MOD2022/0529

Designed by: Raise the Roof E info@raisetherooof.com.au Drawn by: Inlet Design Studio E robyn@inletdesign.com.au	REVISION: A DATE: 4/01/21 REVISION NOTE: Shadow date added	CLIENT: MR AND MRS BAKER ADDRESS: 26 Jeanette Ave Mona Vale	DRAWING: Site Plan and Site Analysis PROJECT: ALTERATIONS AND ADDITIONS PROJECT NO: JEA001 ISSUE TYPE: 2	DRAWN: RJ CHKD: RJ ISSUE DATE: 26/11/20	SHEET NO: A01 SCALE @ A3: 1:200 REVISION: B
	REVISION: B DATE: 09/09/22 REVISION NOTE: Ground Floor Roof design change Additional Balcony Roof, External stair Laundry addition

PROJECT:
ALTERATIONS AND ADDITIONS

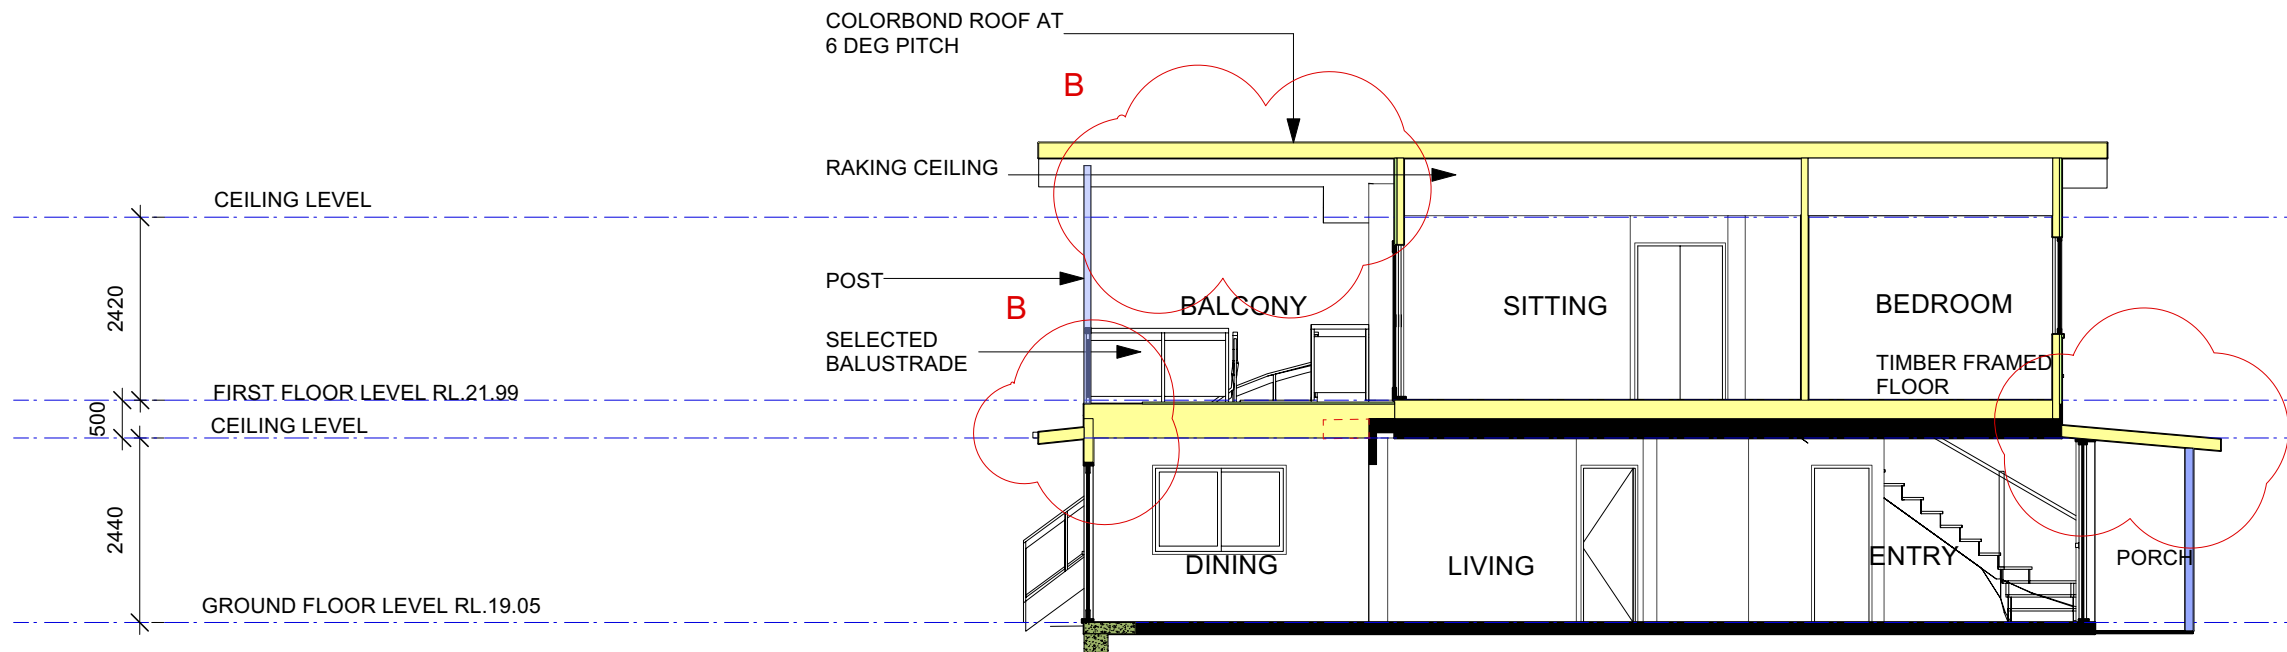
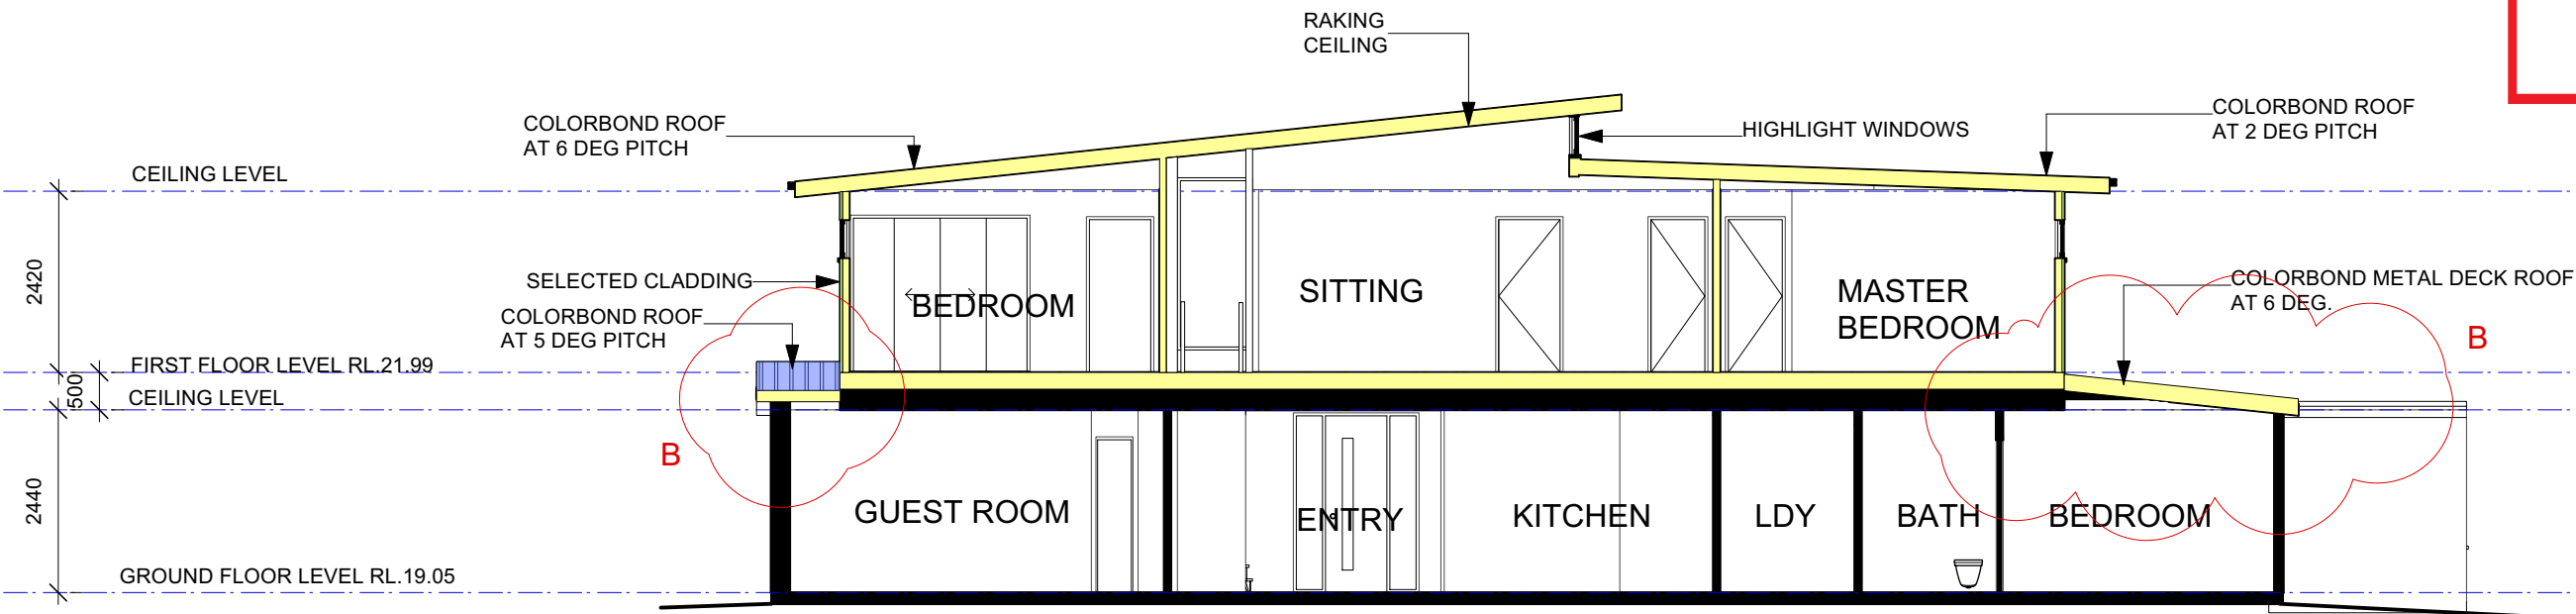
Designed by: Raise the Roof E info@raisetherooof.com.au Drawn by: Inlet Design Studio E robyn@inletdesign.com.au	REVISION: A	DATE: 4/01/21	REVISION NOTE: Shadow date added	 CLIENT: MR AND MRS BAKER ADDRESS: 26 Jeanette Ave Mona Vale	DRAWING: SECTIONS	DRAWN: RJ	SHEET NO: A07
	B	09/09/22	Ground Floor Roof design change Additional Balcony Roof Laundry addition, eaves to ground floor roof		PROJECT: ALTERATIONS AND ADDITIONS	CHKD: RJ	SCALE @ A3: 1:100
					PROJECT NO: JEA001	ISSUE DATE: 26/11/20	REVISION: B
					ISSUE TYPE: 1
